Duke Energy Corporation

June 13, 2002

Subject: Duke Energy Corporation
Oconee Nuclear Station - Units 1, 2, and 3
Docket Nos. 50-269, 50-270, and 50-287

Revisions to Topical Reports DPC-NE-3000, -3003, and
3005 In Support of Steam Generator Replacement

Figure 3.1-2 Westinghouse Robust Fuel Assembly

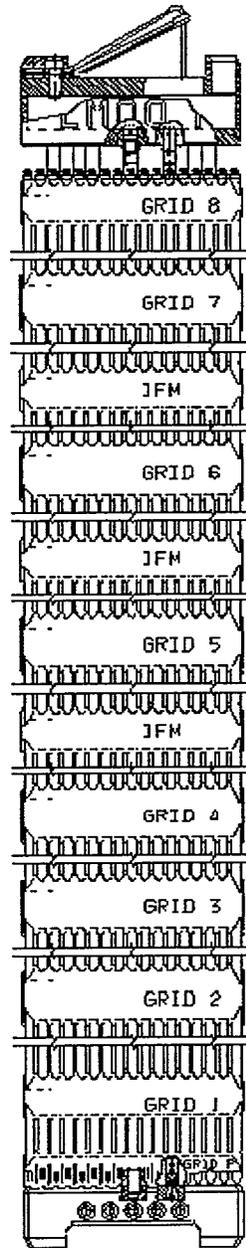
18. Figure 3.1-2 Replace illustration of Westinghouse Optimized Fuel Assembly (OFA) with Westinghouse Robust Fuel Assembly (RFA). The OFA design is no longer used. (design description)

Change: Replace illustration of OFA design with illustration of RFA design.
